## Planning Application Consultation Response

| Application Number          | DM/24/2622                                                                                                                                                                                                                |
| Site Location               | Barns Court Turners Hill Road Crawley Down West Sussex RH10 4HQ                                                                                                                                                           |
| Development Description     | Approval of reserved matters relating to application DM/20/4127 for Access, Appearance, Landscaping, Layout and Scale for Phase 1b comprising of Building M, a double unit workshop, ancillary Building N and yard space. |

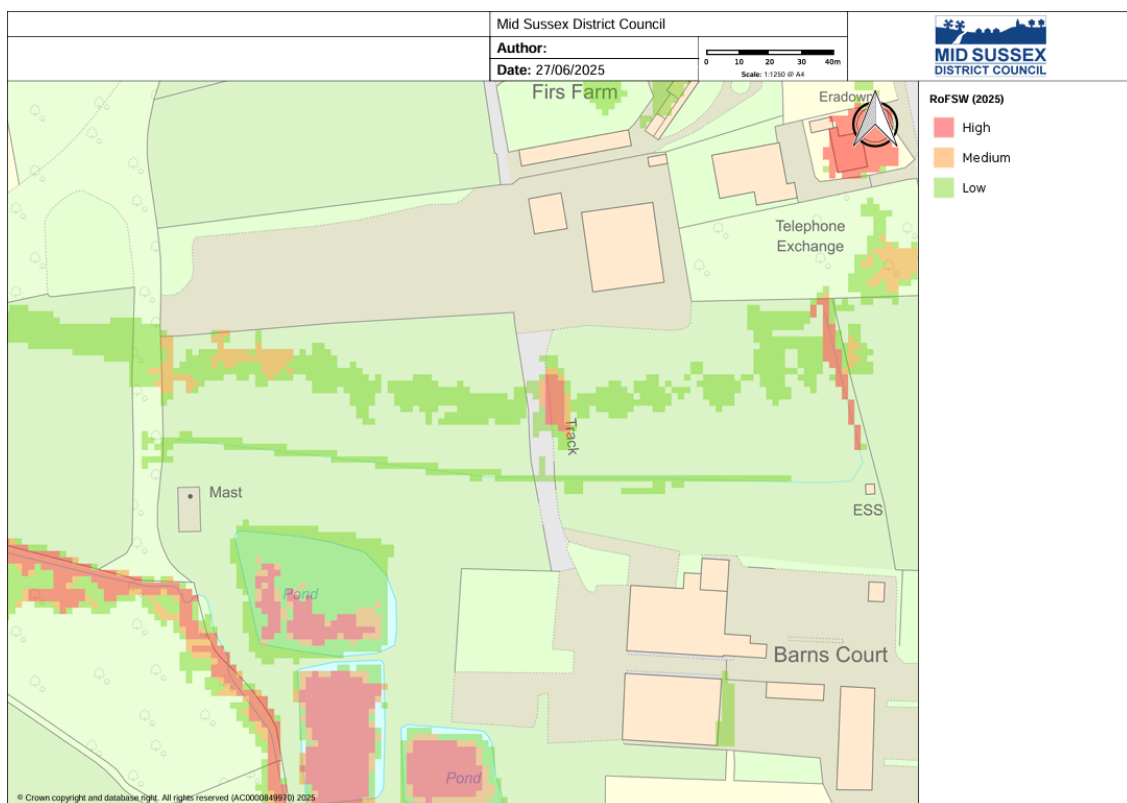
The Risk of Flooding from Surface Water mapping suggests the site is shown to be at very low to medium surface water flood risk (comparable to flood zones 1 and 2) for the present day (2025) and to be at very low to high surface water flood risk (comparable to flood zones 1 and 3b) within the climate change range of 2040 – 2060.

There would appear to be two principle flow paths across the site for surface water, along the ditch present on site, and part of a surface water flow path that crosses the northern half of the site from east to west.

Based on the latest guidance that all sources of flooding should be considered consistently, part of the site would be considered to be partially within the functional floodplain (Flood Zone 3b); it's location part within the 1:30 surface water flood extent with climate change.

It has not been demonstrated that there will be no increase in built footprint or land raising within the surface water 1:100 year plus climate change extent. The applicant needs to provide evidence that the proposed development will not increase flood risk on site or elsewhere. There should be no increase in built footprint or land raising within the 1 in 100 year plus climate change extent. The 1:1000 year plus climate change (2040-2060) extent is a

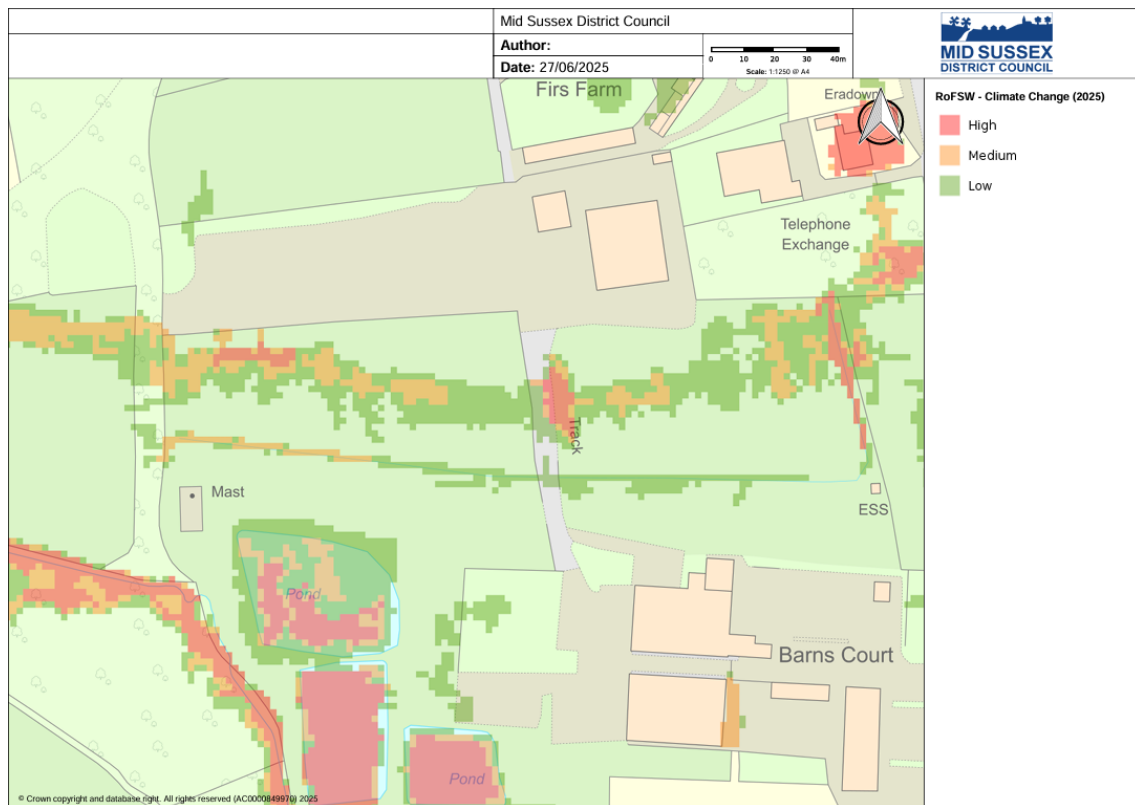
The applicant has not overlain the proposed built footprint on site onto the EA's surface water mapping, and as such it has not been demonstrated that there is no increase in built footprint within Flood Zone 3b or within the surface water 1:100 year plus climate change extent.

The applicant should also demonstrate the onward connectivity of the ditch on site, and how surface water flow across the site will be managed with the absence of the ditch.

The flow route across the site from east to west forms part of the wider areas natural surface water drainage. Existing surface water flow routes should be maintained post development.
